# UNITED STATES PATENT AND TRADEMARK OFFICE

APPLICATION NO.	FILING DATE	FIRST NAMED INVENTOR	ATTORNEY DOCKET NO.	CONFIRMATION NO.
10/019,195	06/03/2002	Hans-Jurgen Hannig	009646/00004.3	6251
25223	7590	01/03/2007	EXAMINER	
WHITEFORD, TAYLOR & PRESTON, LLP			GARCIA, ERNESTO	
ATTN: GREGORY M STONE			ART UNIT	PAPER NUMBER
SEVEN SAINT PAUL STREET			3679	
BALTIMORE, MD 21202-1626				
SHORTENED STATUTORY PERIOD OF RESPONSE	MAIL DATE		DELIVERY MODE	
3 MONTHS	01/03/2007		PAPER

<b>Office Action Summary</b>	<b>Application No.</b>	<b>Applicant(s)</b>
	10/019,195	HANNIG ET AL.
	<b>Examiner</b>	<b>Art Unit</b>
	Ernesto Garcia	3679

**DETAILED ACTION**

FIG. 8

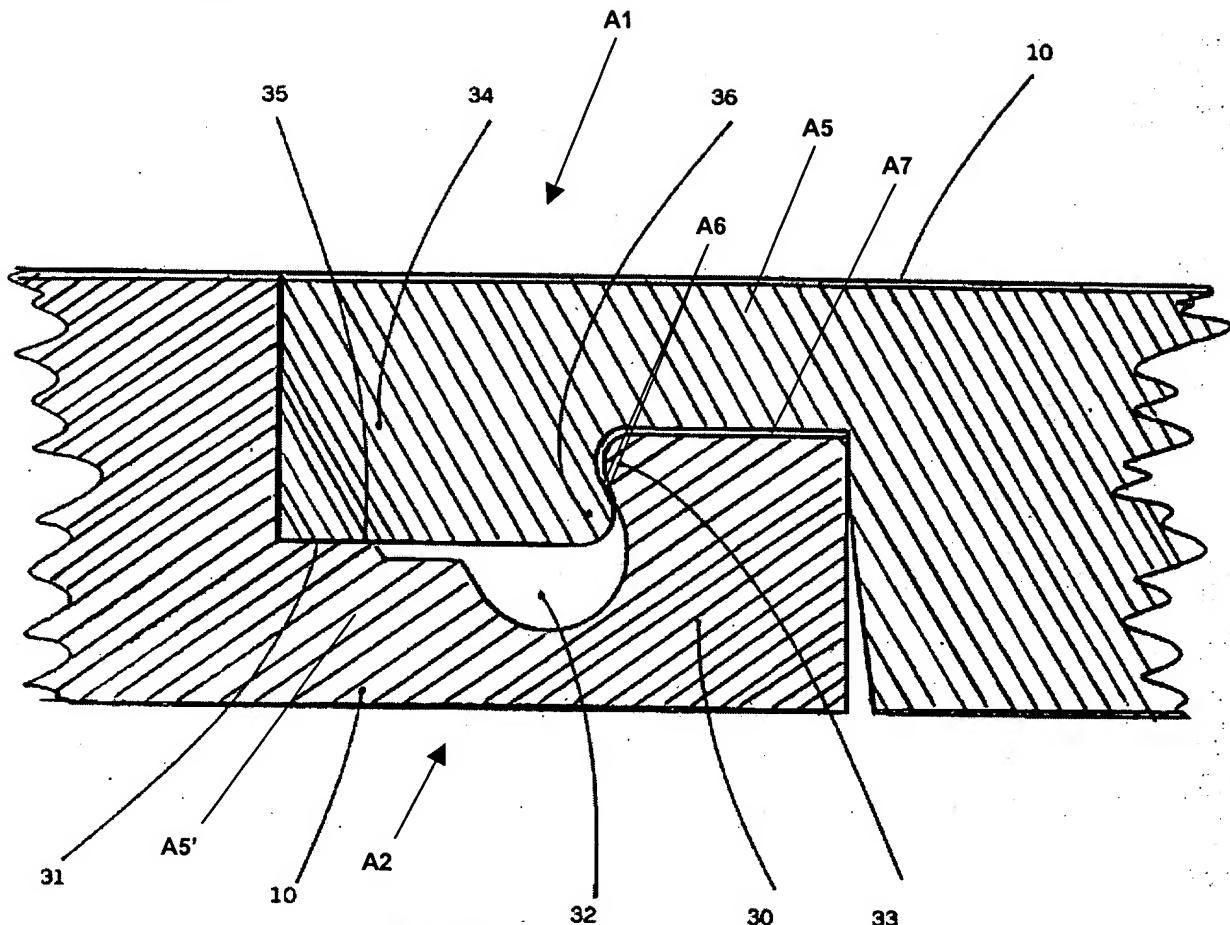
Regarding claim 8, Zancai discloses, in Figure 8, a fastening system comprising a first panel 10 and a second panel 10. The first panel 10 and the second panel 10 are rectangular. The narrow sides of the panels have mutually oppositely disposed retaining profiles A1,A2. One of the retaining profiles A1,A2 of the first panel matches with one of the retaining profiles of the second panel thus forming oppositely disposed retaining profiles having complementary hook elements 30,34. The hook elements have hook projections 33,36 connected to legs A5,A5' of the first panel 10 and the second panel 10. Each of the hook projections has a retaining surface A6 being inclined such that the hook projections are reduced from their free ends towards the legs A5,A5'. The retaining surfaces A6 bear against each other. The hook projection 33,36 of the first panel bears against the leg at the second panel. Intermediate spaces 32, A7 are provided with clearance and form adhesive pockets.

Regarding claim 31, Zancai discloses, in Figure 8, a fastening system comprising a first panel 10 and a second panel 10. The first panel 10 and the second panel 10 are rectangular. The narrow sides of the panels have mutually oppositely disposed retaining profiles A1,A2. One of the retaining profiles A1,A2 of the first panel matches with one of the retaining profiles of the second panel thus forming oppositely disposed retaining profiles having complementary hook elements 30,34. The hook elements have hook projections 33,36 connected to legs A5,A5' of the first panel 10 and the second panel 10. Each of the hook projections has a retaining surface A6 being

inclined such that the hook projections are reduced from their free ends towards the legs **A5,A5'**. The retaining surfaces **A6** bear against each other. The hook projection **33,36** of the first panel bears against the leg at the second panel. A clearance **A7** is provided between a hook projection **30** of the second panel **10** and a leg **A5,A5'** of the first panel.

Regarding claim 3, Zancai discloses, in Figure 8, a fastening system comprising a first panel **10** and a second panel **10**. The first panel **10** and the second panel **10** are rectangular. The narrow sides of the panels have mutually oppositely disposed retaining profiles **A1,A2**. One of the retaining profiles **A1,A2** of the first panel matches with one of the retaining profiles of the second panel thus forming oppositely disposed retaining profiles having complementary hook elements **30,34**. The hook elements have hook projections **33,36** connected to legs **A5,A5'** of the first panel **10** and the second panel **10**. Each of the hook projections has a retaining surface **A6** being inclined such that the hook projections are reduced from their free ends towards the legs **A5,A5'**. The retaining surfaces **A6** bear against each other. The hook projection **33,36** of the first panel bears against the leg at the second panel. A clearance **A7** is

provided between a hook projection 30 of the second panel 10 and a leg A5,A5' of the first panel. However, the hook projection that bears against the leg at a top side of the second panel is not at an underside. Applicant is reminded that a mere reversal of the essential working parts of a device involves only routine skill in the art; therefore, it would have been obvious to one having ordinary skill in the art at the time the invention was made to reverse the hook projections such that the hook projection of the second panel that bears with the leg is at an underside and the leg is at the top side. *In re Einstein*, 8 USPQ 167.
